UNITED STATES PATENT AND TRADEMARK OFFICE

APPLICATION NO.	FILING DATE	FIRST NAMED INVENTOR	ATTORNEY DOCKET NO.	CONFIRMATION NO.	
10/771,999	02/04/2004	Nathan Taylor	NATNAN POIAUS	5161	
20210 75	590 11/21/2006		EXAM	EXAMINER	
DAVIS & BUJOLD, P.L.L.C. 112 PLEASANT STREET			PAHNG, JASON Y		
CONCORD, NH 03301			ART UNIT	PAPER NUMBER	
, ,			3725		
•			DATE MAILED: 11/21/2006	6

DETAILED ACTION

Figure 4 (Modified)

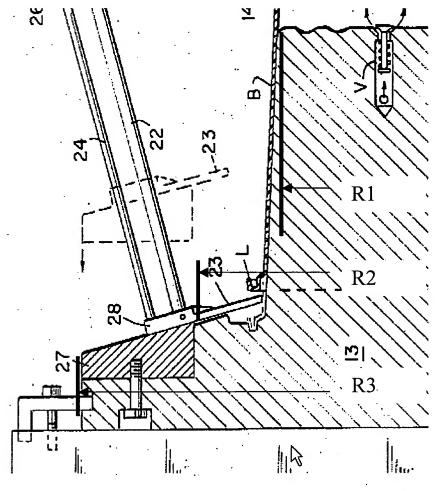
With regard to claim 1, Bendzick discloses an expandable basket mold (expended in Figure 2 and compressed in Figure 1) for making a basket comprising a plurality of separate mold sections(11, 13, and 27) comprising at least a bottom section (13) and a top section (27) defining a contiguous circumferential sidewall (outer side surface of 11 and 27 in Figure 2) extending between a top surface (top of 12) and a bottom surface (bottom of 10) of the basket mold; and wherein the plurality of separate mold sections (11, 13, and 27) are secured together to form the basket mold by a

releasable fastening mechanism (at least between 13 and 27; See Modified Figure 4 below).

With regard to claim 17, Bendzick discloses each mold section defined by an upper surface having an upper radius (R3 in Modified Figure 4 below) slightly larger than a lower radius (R2 in Modified Figure 4) of a lower surface of the mold section and the lower radius (R2) of each successive mold section from the bottom section substantially matching the upper radius (R2) of the preceding mold section to form the radially increasing contiguous sidewall extending between the top and bottom surface of the mold.

FIG. 1

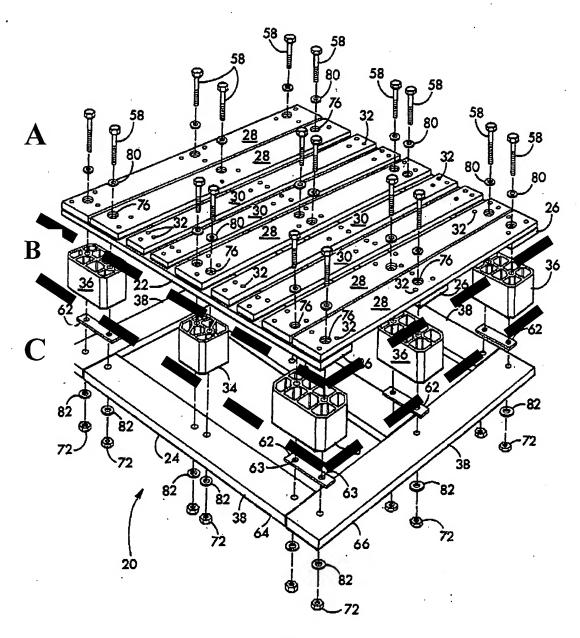
a plurality of separate mold sections (A, B and C, modified Figure 1 below)
 comprising a bottom section (C, modified Figure 1 below) and a top section
 (A, modified Figure 1 below) defining a contiguous circumferential sidewall

(38) extending between a top surface (top of A) and a bottom surface (bottom of C) of the basket mold (modified Figure 1 below);

2. the sections are secured together by a releasable fastening mechanism (58).

With regard to claim 3, Breezer discloses an intermediate mold section (B, modified Figure 1).

With regard to claim 4, Breezer discloses a first mold defined by the bottom section (C, modified Figure 1) and the top section (A, modified Figure 1). Breezer also discloses a second mold defined by another separate mold section (B, modified Figure 1) in addition to the first mold.

Applicant also argues that Breezer does not provide a sidewall portion which is contiguous between an upper and lower surface of each mold section and extends circumferentially about the entire mold (page 8). This is not true. Breezer discloses a circumferential sidewall (38) in Figure 1.
